| APPROVALS | | DATE | | TITLE: SERVICE BULLETIN WSB IDU-III-18 (GARMIN GDL-90 ADS-B INTERFACE PROVISIONS) | |

EQUIPMENT: IDU-III

BULLETIN NUMBER: WSB IDU-III-18 Revision A

Figure 1 GDL-90 to PFD Interface

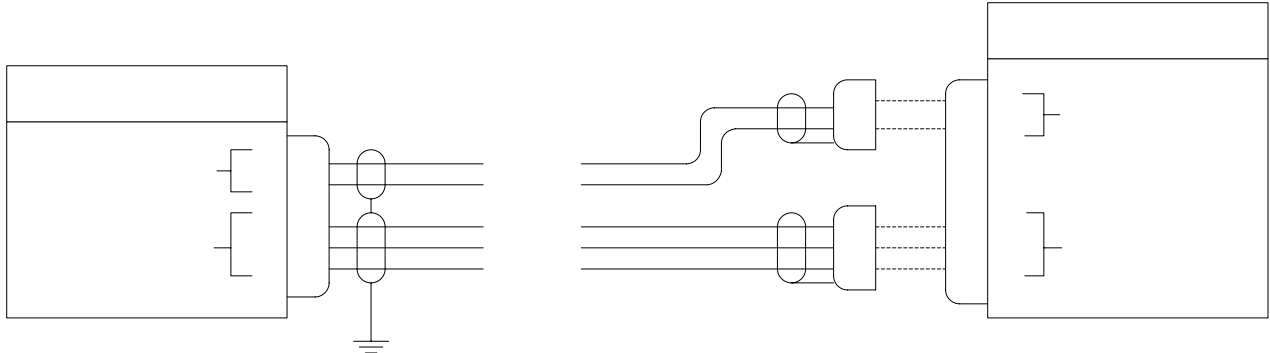
1. Remove power from the aircraft and disconnect the aircraft battery.
2. Remove all required access panels and aircraft interior for installation.
3. Locate and install the Garmin GDL-90 ADS-B sensor per the Garmin Installation Manual.
4. Route one AWG22SH3C (Item 1) and one AWG22SH2C (Item 2) from the ADS-B sensor to the PFD tray assembly.
5. Secure wires to existing harnesses and structures per AC 42.13-1B, Chapter 11, Sections 8 through 12 as required.
6. Terminate wires in Step 2 at the GDL-90 using sockets provided in the Garmin Installation Kit and attach per Figure 1.

7. Terminate the shield per Garmin Installation Manual, Doc. 560-1049-00, Chapter 2.
8. Terminate wires in Step 2 at the PFD using sockets (Item 3) per Chelton EFIS Installation Instructions, Doc. 150-045264, Chapter 2 and attach per Figure 1.
9. Terminate the shield per Chelton EFIS Installation Instructions, Doc. 150-045264, Chapter 2 and attach per Figure 1.
10. Disconnect the EFIS Interconnect Cable by removing PFD P4 and MFD P3 from the tray.

Figure 2 PFD to MFD EFIS Interconnect Cable

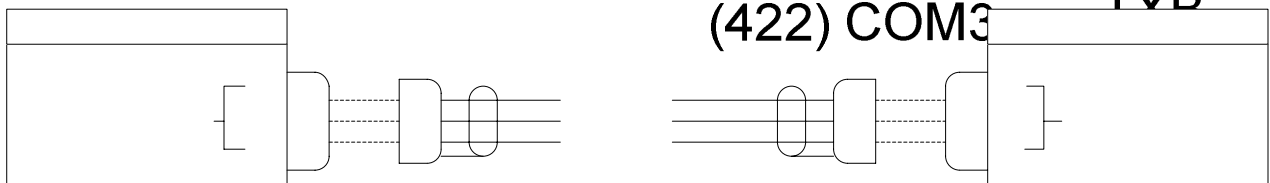
11. Route one AWG22SH3C (Item 1) between the interconnect plugs.
12. Terminate the wires in Step 10 using sockets (Item 3) per Chelton EFIS Installation Instructions, Doc. 150-045264, Chapter 2.
13. Terminate the shield per Chelton EFIS Installation Instructions, Doc, 150-045264, Chapter 2.
14. Add new wires per Figure 2.

15. Secure new wire to the EFIS Interconnect Cable.
16. Install EFIS Interconnect Cable into aircraft.
